8.0 RESPONSES TO COMMENTS ON THE DRAFT EIR

This section includes comments received during the circulation of the Draft Environmental Impact Report prepared for the Zone 2 Landslide Moratorium Ordinance Revisions Project (Project).

Zone 2 Landslide Moratorium Ordinance Revisions EIR
Section 8.0 Responses to Comments on the Draft EIR

Figure 8.0-1

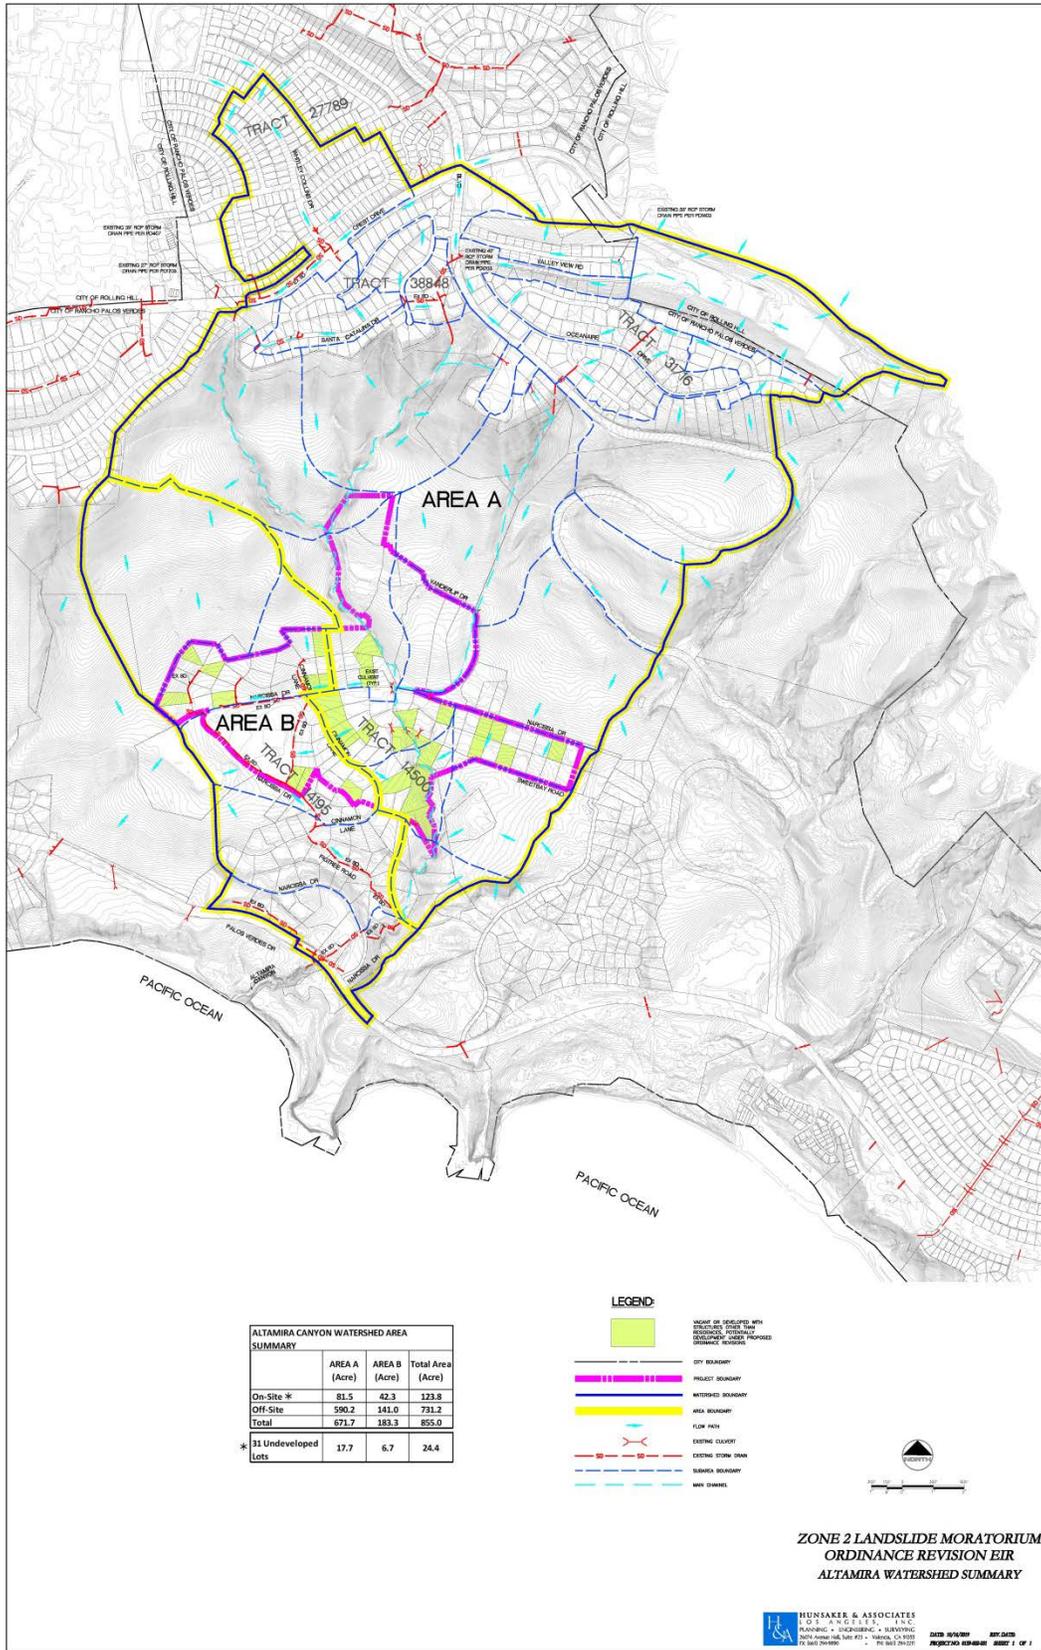
The commenter notes that the increase in water volume in Altamira Canyon from new project area development would be de minimis and suggests the addition of a map to the Final EIR showing the entire area that drains into Altamira Canyon and the 31 undeveloped lots.

It is agreed that the increase in water volume draining into Altamira Canyon would be minimal and, as discussed in Section 4.8, *Hydrology and Water Quality*, of the Draft EIR, such impacts can be reduced to a less than significant level with standard engineering practices. A map of the Altamira Canyon Watershed is included as Figure 8.0-1 below.

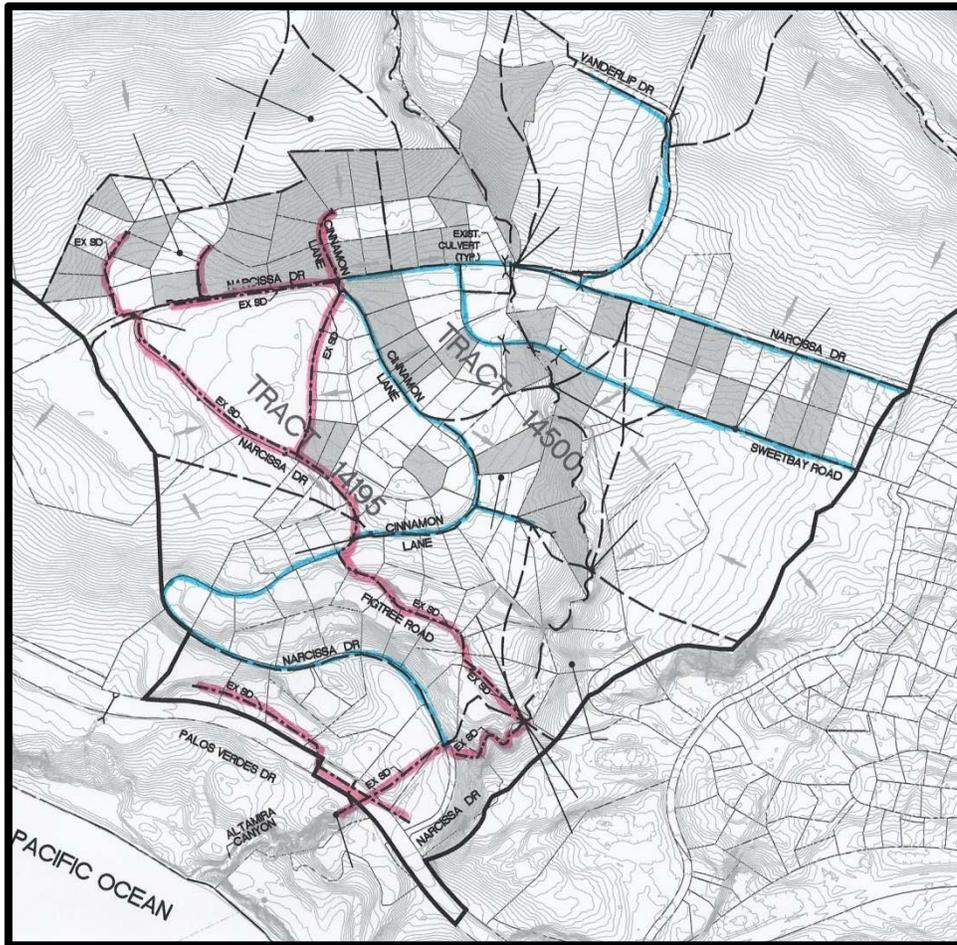
The present storm drain system in Zone 2 and adjacent areas (shown below) is taken from the Draft EIR section on flooding and hydrology, figure 4.8-1. The storm drain system shown in red on the map is based on the City of RPV 2004 revised edition of the city's storm drains. Unfortunately, as shown it is incomplete and only covers the west side of the community. The

illustration omits the storm drain system in the rest of Zone 2, mostly the east side. In blue is the rest of the system covering Vanderlip Drive, upper Narcissa Drive, lower Cinnamon Lane, Sweetbay Road and lower Narcissa within the Abalone Cove landslide, all of which are important in conveying storm water runoff into Altamira Canyon. Also note that the 300 feet of Altamira Canyon located between the end of the culvert exiting Fig Tree Road and the 120" CMP culvert at the entrance (beneath the park) is included in the City/EIR's storm drain system.

It is important to recognize the complete system because all of the streets and culverts in the community are involved in conveying storm water runoff from houses and open lots into Altamira Canyon. All parts of the system are important and must function successfully in order to prevent flooding and the type of problems that have plagued the community for years.

The storm drainage system in Zone 2 and adjacent areas. Outlined in red is the system illustrated in the revised Draft EIR report (fig. 4.8-1). Shown in blue is the rest of the functioning storm drain system in Zone 2 and adjacent community.

A.1 Under-capacity of the Existing Storm Drain System

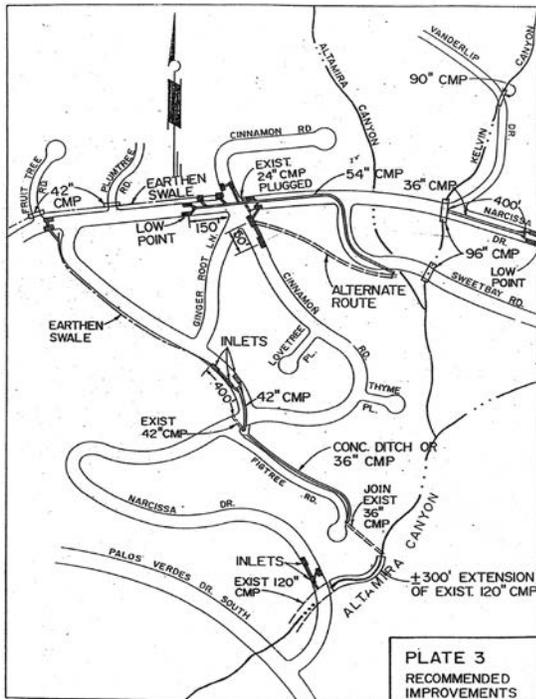
In the EIR, the hydrologic analyses determined that post-development conditions would result in an increase in storm drain runoff as a result of the increase in impervious area that would occur when the 47 lots are developed. However, they conclude that the combined impact from the development is insignificant for the following reasons:

Background: The EIR statement that the “existing drainage system was designed for the entire Portuguese Bend development, including the 47 undeveloped lots” is an overstatement. The storm drain system in Zone 2 is the streets in the community, with a few culverts that connect streets and convey storm water into Altamira Canyon. The streets in Zone 2 are simply the paved over dirt roads established by farmers early in the 20th century and addition and modification to the streets during development in the 1940-1950s was to maximize the number of buildable lots, not to improve storm water drainage. It is safe to say that the current street “system” was never “designed” for anything other than to provide access to the community.

In 1990 ASL Consulting Engineers recommended eight major improvements to upgrading the storm drain system (left) but only two minor modifications to the then existing system were made and the system today remains basically as it was in pre-1990.

A.2 Unresolved drainage problems

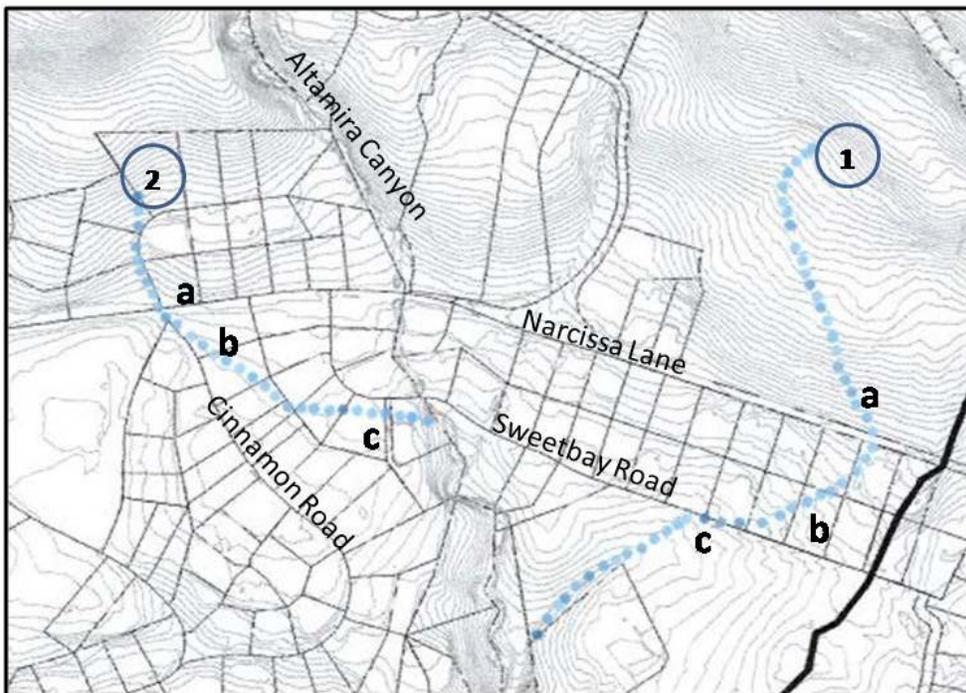
There are two unresolved drainage problems that have affected the project area for many years and impact the adequacy of the current system. Both are old, natural drainage channels which collect rain water from upslope areas above Zone 2. They can be identified in old topographic maps, aerial photos and surface photographs and were never adequately addressed in development of the storm drain system. During major rain storms storm water flows through the channels, spills out on to adjacent lots and causes local flooding and erosion. Both channels cross open, undeveloped lots and should be addressed before development of the lots.

The location of old, natural drainage channels (shown in blue) which drain upslope areas and convey surface runoff water in major rain storm events. Channel 1 drains the area generally south of the old Crenshaw Extension and Channel 2 drains upslope areas north of upper Cinnamon Road. Letters identify location of the photos.

Location 1a, (left) drainage ditch cut into the slope to direct water into the inlet (lower right) to the culvert that runs under upper Narcissa Drive. Sheet flow from upslope areas overflowed the ditch and culvert and flooded Narcissa Lane during high rainfall years in the 1990s (e.g. 1995, 1998) and 2000s (2001, 2005, 2010). In the February, 2005 storm runoff that originated in the area north of Peacock Flats, flowed (raced) down the Crenshaw Extension dirt road, jumping the road at the sharp curve east of Kelvin Canyon and flowed down the slope above Narcissa Drive. The storm water flooded upper Narcissa and over whelmed the channels between Narcissa and Sweetbay Road.

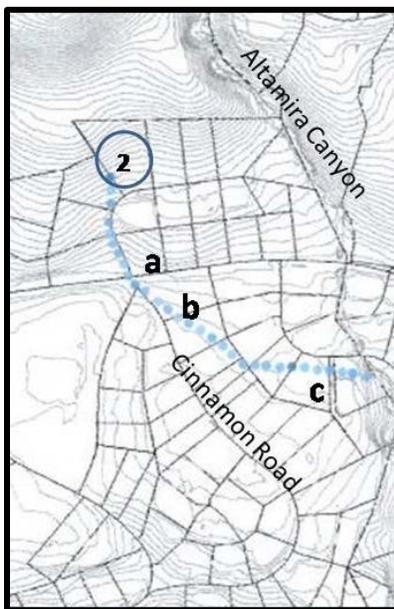
(left) The California Water Service water main exposed by erosion in the northern channel following the 2005 storm (it remains exposed today).

1c (right) Storm water flows (west) across Sweetbay Road and exists at the trees (1c) into the continuation of the old channel. Storm water eventually flows into Altamira Canyon

B. Increased infiltration

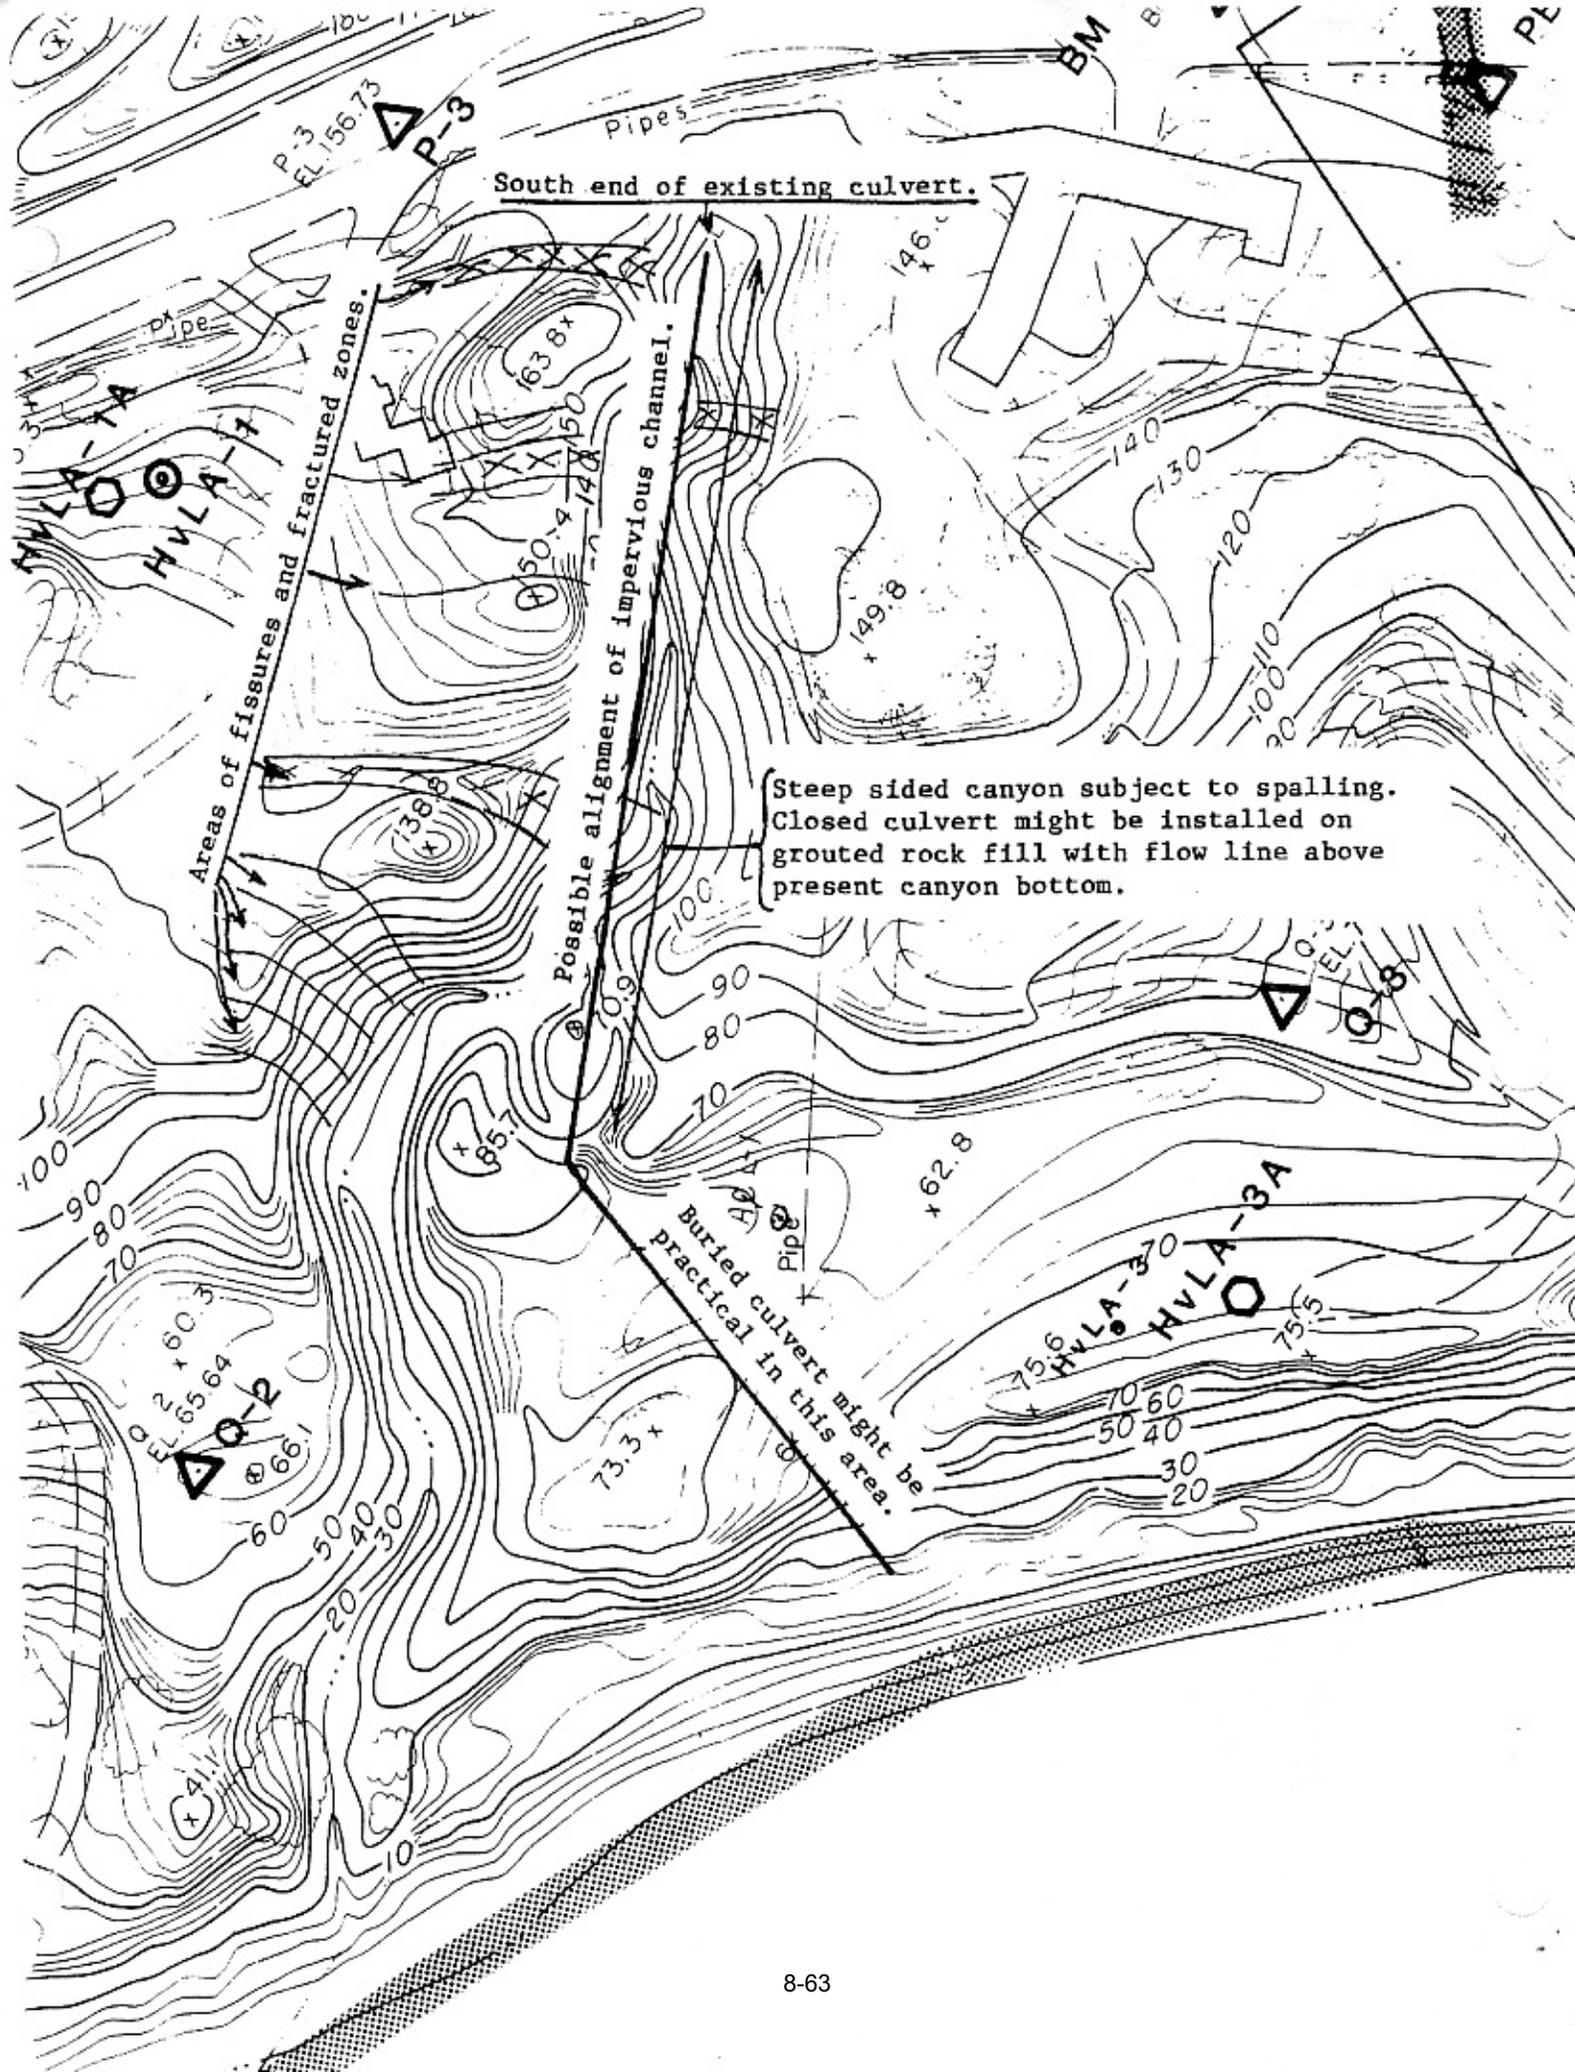
The EIR analysis indicates that “the addition of impervious areas (new houses) will reduce the total infiltration in the project site and due to the low permeability of the soils and steepness of the canyon sides, for a given storm event, the total infiltration will not exceed the existing condition”. This hardly seems possible when, as the analyses states, more runoff water will be entering the streets with the development of the 47 lots and, eventually, into Altamira Canyon. Studies (Hill, 2000; Hill, et al, 2007) reveal that the infiltration in the bottom of Altamira Canyon is one of the major sources of recharging the groundwater. The photos below, taken about 15-20 minutes apart in December 2010 , illustrate the problem: On the left is

storm water discharging from the 120" CMP culvert in Altamira Canyon at the crossing with upper Narcissa Drive.

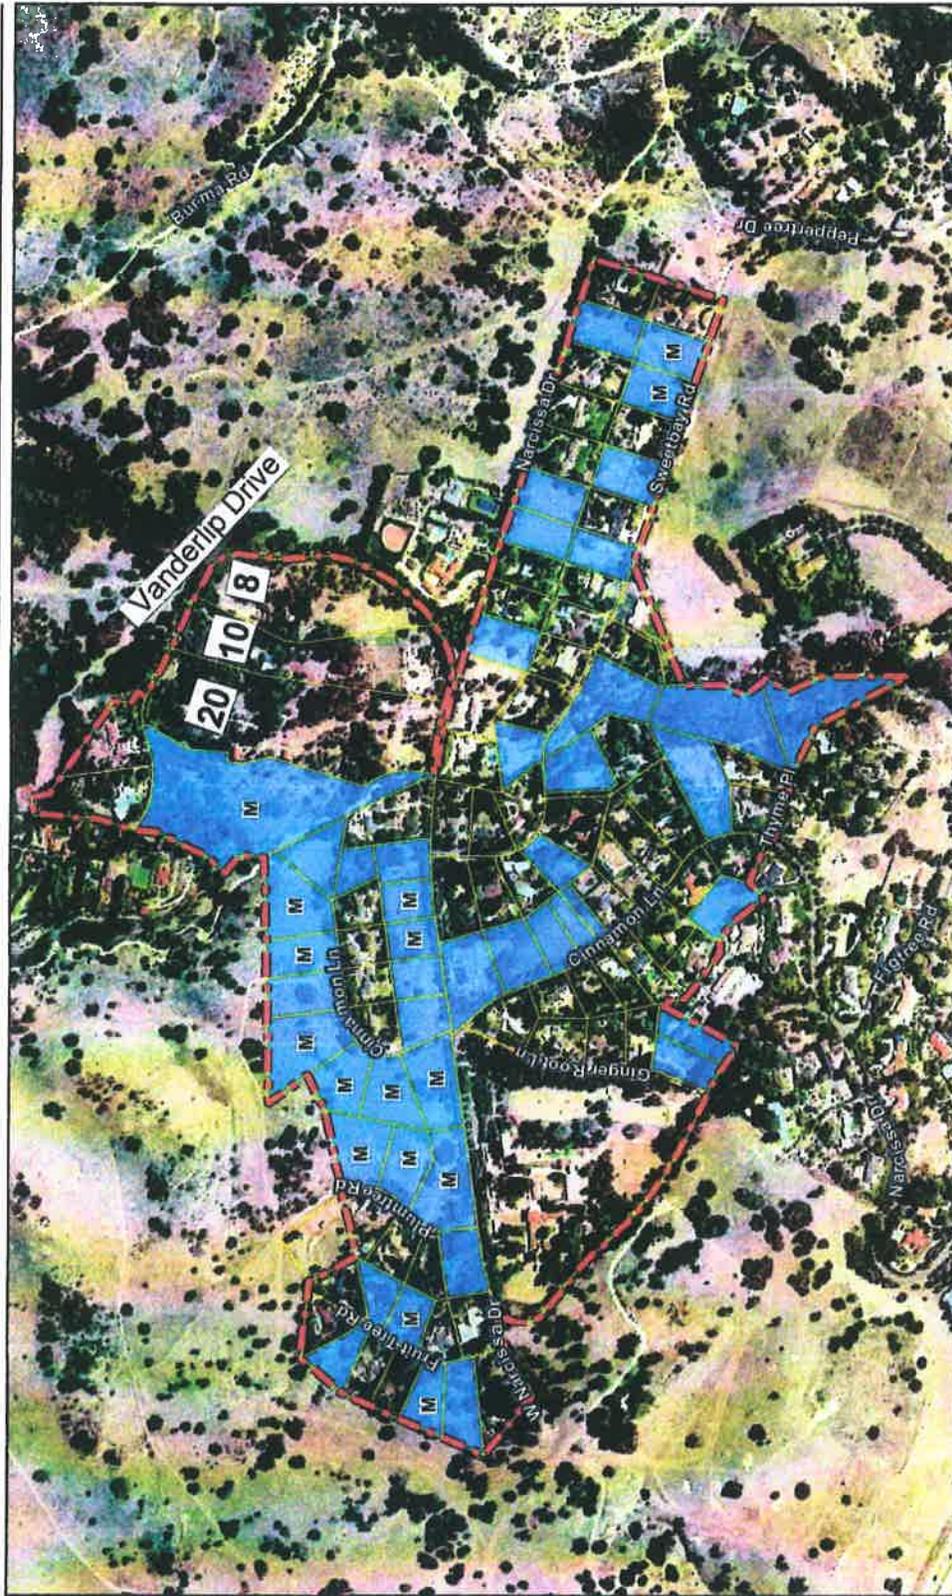
Lots 8, 10 and 20’s DEIR questions could go on and on. They are not part of our Portuguese Bend Community Association and so as ‘orphan’ lots are subject only to my city’s rules and regulations.

1. **My city’s Parcel Map showing Vanderlip Drive lots 8, 10 and 20 in comparison to Monks and the 31 subject lots. (A picture is worth a thousand words!)**
 2. **My ‘Late Correspondence’ on this subject for the recent Council meeting.**
 3. **Letters from 2009 from each lot owner re lot splits. (That’s 10 years ago!)**
 4. **A list of partial documentation we hold validating Jack Downhill’s historical lot split saga.**
- 40.5

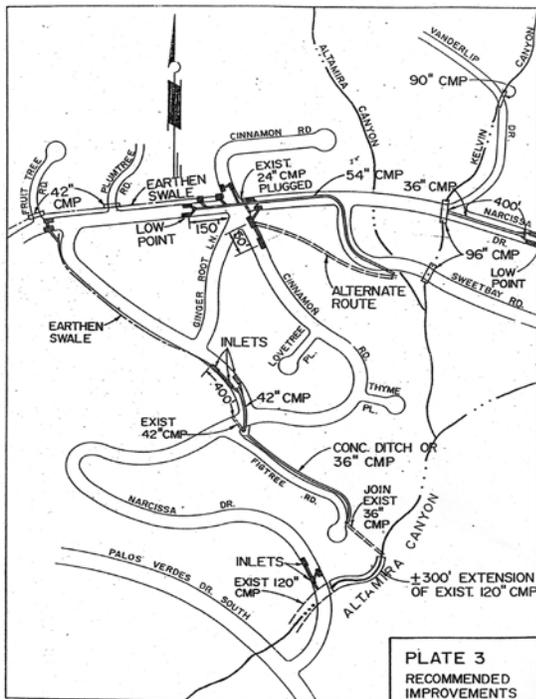
It seems to me that too many of the mitigations proposed are on a lot by lot basis and don’t take a more global view of the existing conditions, problems and solutions.

It seems completely unreasonable to not fix the underlying major problems that are vital to the safety of our community before allowing further development.

Fix the fissures in Altamira canyon so that storm water runoff doesn’t recharge the groundwater levels and destabilize zone 5.
